E8364BH85-01

S E R V I C E N O T E

E8364BH85 PNA Series RF Network Analyzers

Figure 1

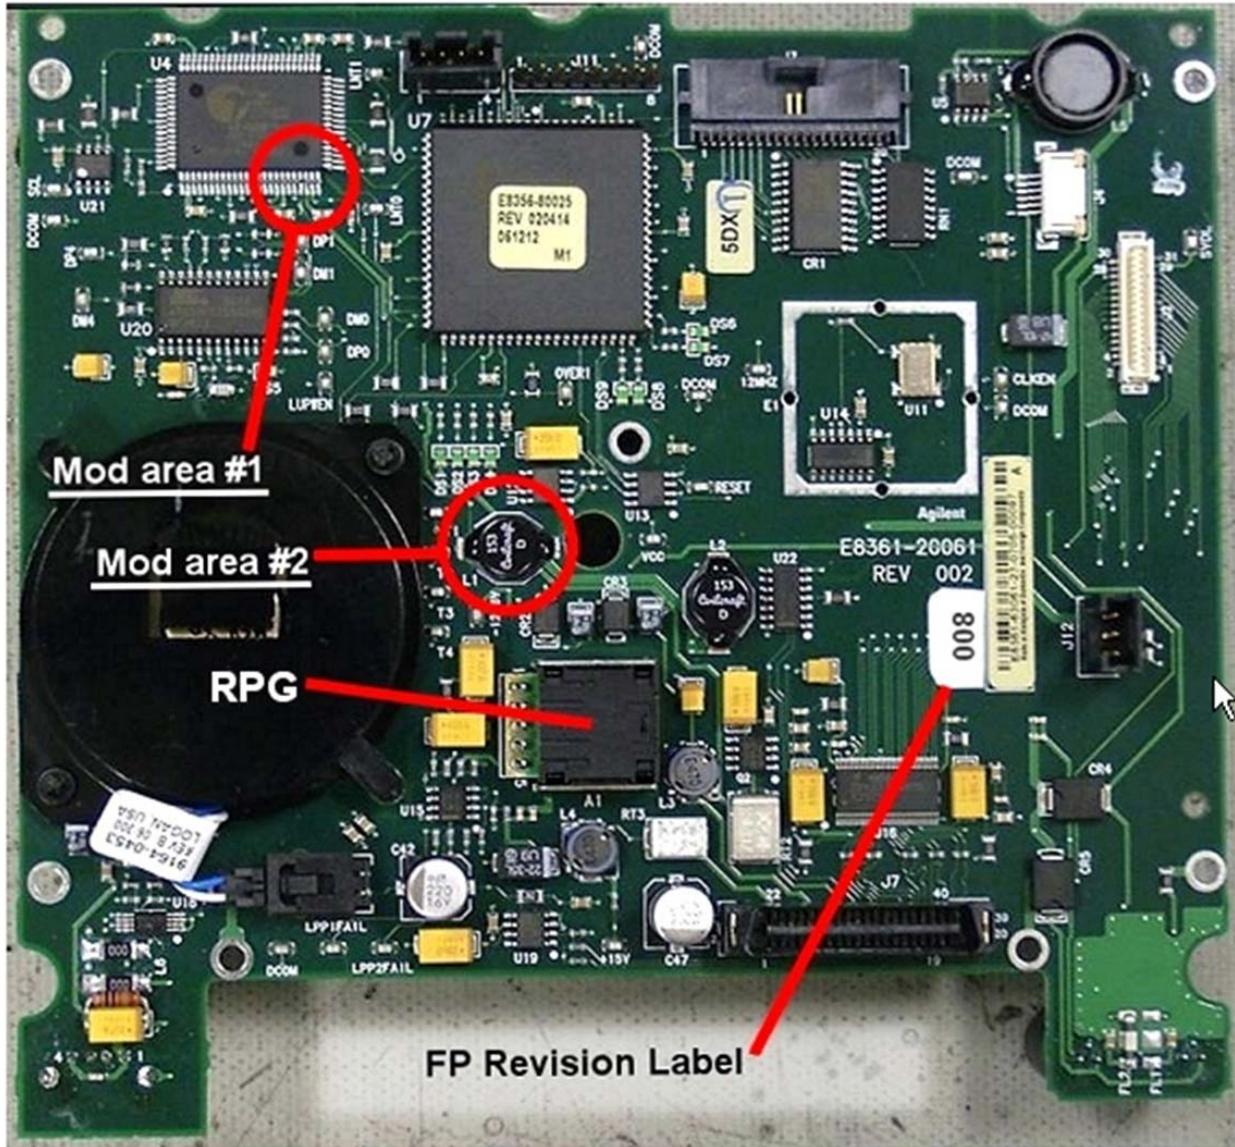
Refer to Figure 1 for the two modification areas to be addressed. Note that while this picture happens to show the FPI board completely removed from the front frame assembly, this is not necessary to perform the required modifications.

- Modification #1 consists of shorting two pins of U4 together with a small amount of solder.
- Modification #2 consist of removing L1.

Figure 2

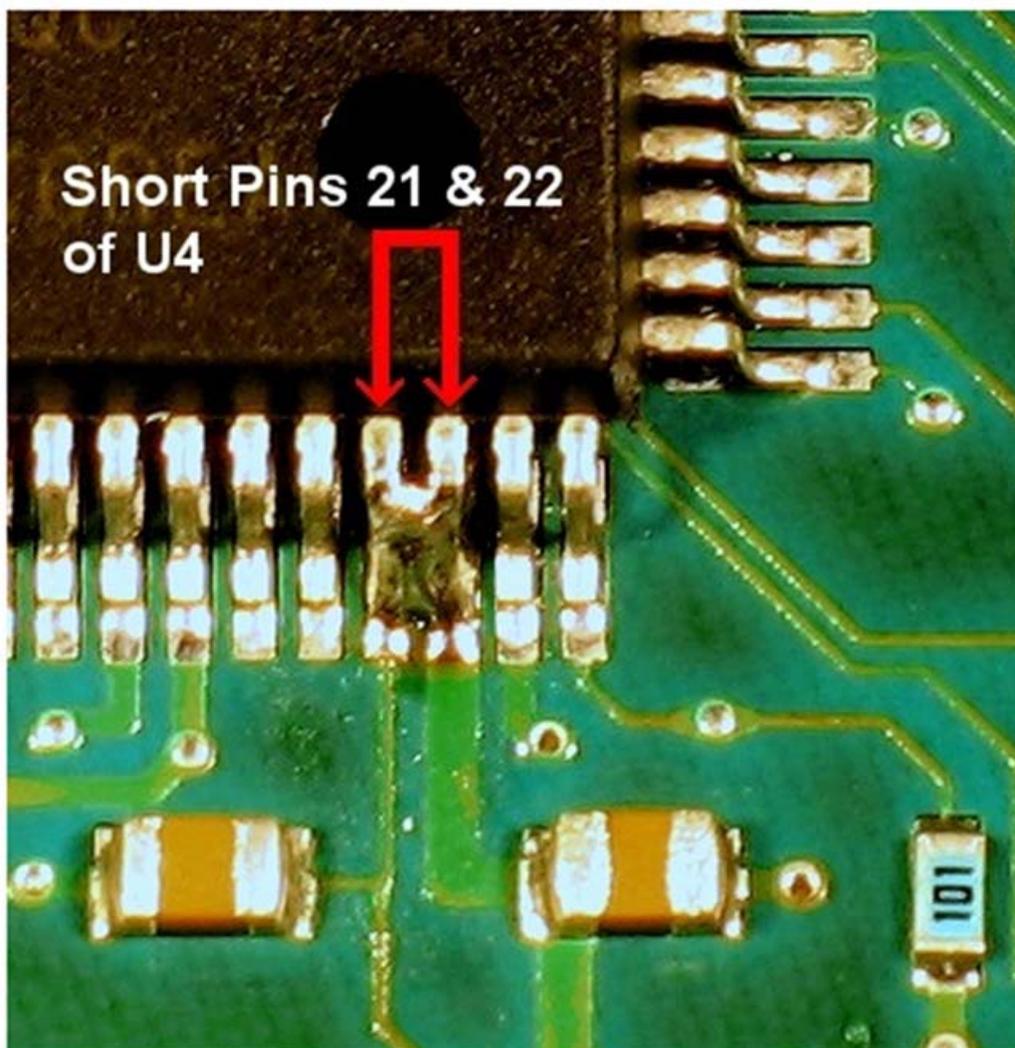
Carefully solder pins 21 and 22 together on U4. Refer to Figure 2 for the exact location. Use care so that no other pins are shorted. Use of a very fine tip soldering iron is recommended and a large work-task magnifying glass is very helpful.

Unsolder and completely remove the black surface mount inductor L1 from the front panel assembly board. This is no longer needed and can be discarded.
